PUBLIC UTILITIES COMMISSION

July 25, 2014

Subject: Crazy Horse Canyon Switching Station Project—Review of Minor Project Modification #12

CIVIL
 SITE IMPROVEMENT
 CRAZY HORSE CANYON SWITCHING STATION
 DEPARTMENT OF ENGINEERING
 PACIFIC GAS AND ELECTRIC COMPANY
 SAN FRANCISCO, CALIFORNIA

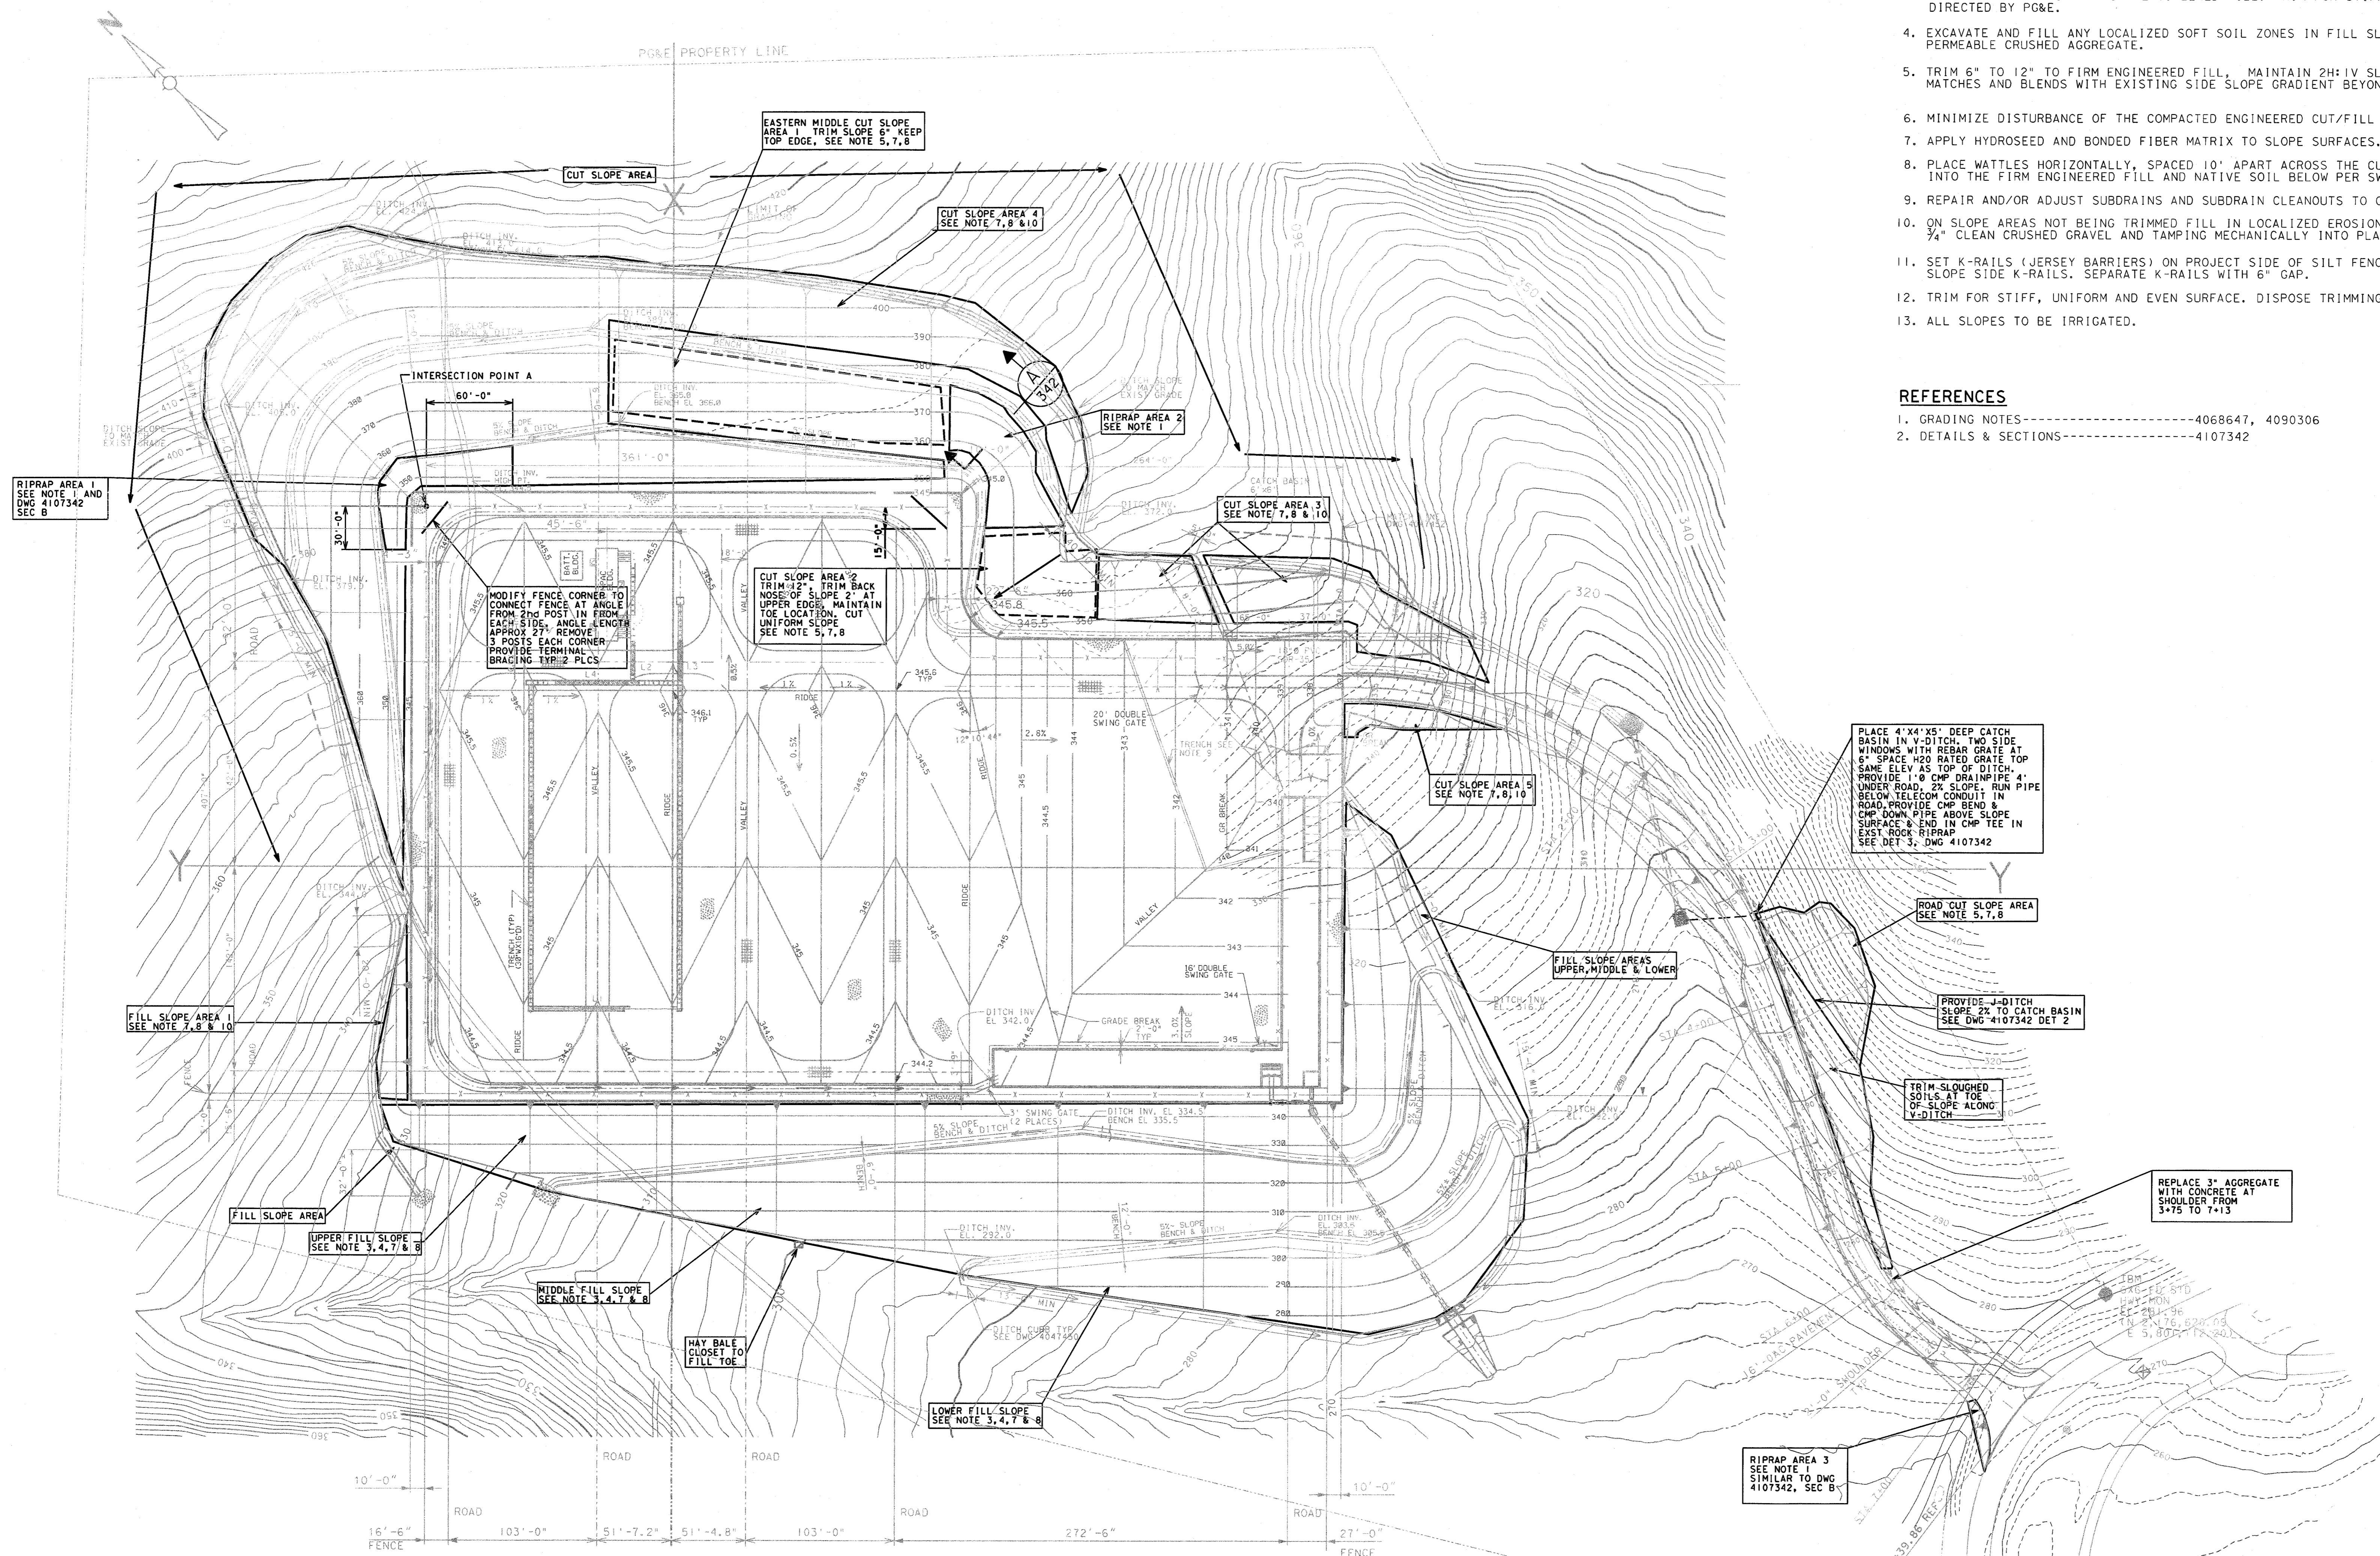
PG&E proposes to modify the engineered slopes and drainage system surrounding the switching station to the north and south, and along the paved access road from San Juan Grade Road to the east and west, in order to better stabilize the slopes from erosion. The following modifications are proposed by slope location (see attached construction drawing):

- Existing rills would be filled in with ¾ inch gravel.
- Multiple locations would be benched (excess soil removed and flattened)
- Rip-rap (rock) would be stacked over geofabric at multiple locations.

- The majority of slopes would be graded to trim approximately 6 to 12 inches of excess topsoil and compacted soil, and to maintain a 2:1 slope.
- Install a K-rail and hay bale wall along the toe of the slope to act as a runoff filtration barrier. The K-rails would be removed after two to three years, once the slopes were secure and well established with vegetation.

- Along the east side of the access road, a 4- by 4- by 5-foot catch basin would be placed in the V-ditch along the shoulder, and a 12-inch corrugated metal drain pipe would be placed under the road at a 2 percent slope.
- Rip-rap would be installed immediately south of the access road entrance.

PG&E anticipates that a total of approximately 6,070 cubic yards of soil would be removed from the engineered slopes covering an approximately 250,000-square-foot area. Removed soil would be transported offsite to a landfill or other appropriate facility. Approximately 210 cubic yards of crushed rock would be used to fill in rills on the upper slope.

CPUC has determined that the proposed actions would be consistent with the approved Final Initial Study/Mitigated Negative Declaration (IS/MND) developed for the project and would not result in new significant impacts, or significantly greater impacts than those analyzed in the IS/MND. A description of the proposed actions and review findings are presented in this letter.

Implementation of the proposed actions described in this letter would not result in new or significantly greater impacts to the environment, and do not present new substantial

information that would change the findings presented in the IS/MND. The MPM is consistent with the analysis presented in the IS/MND and additional CEQA review is not required.
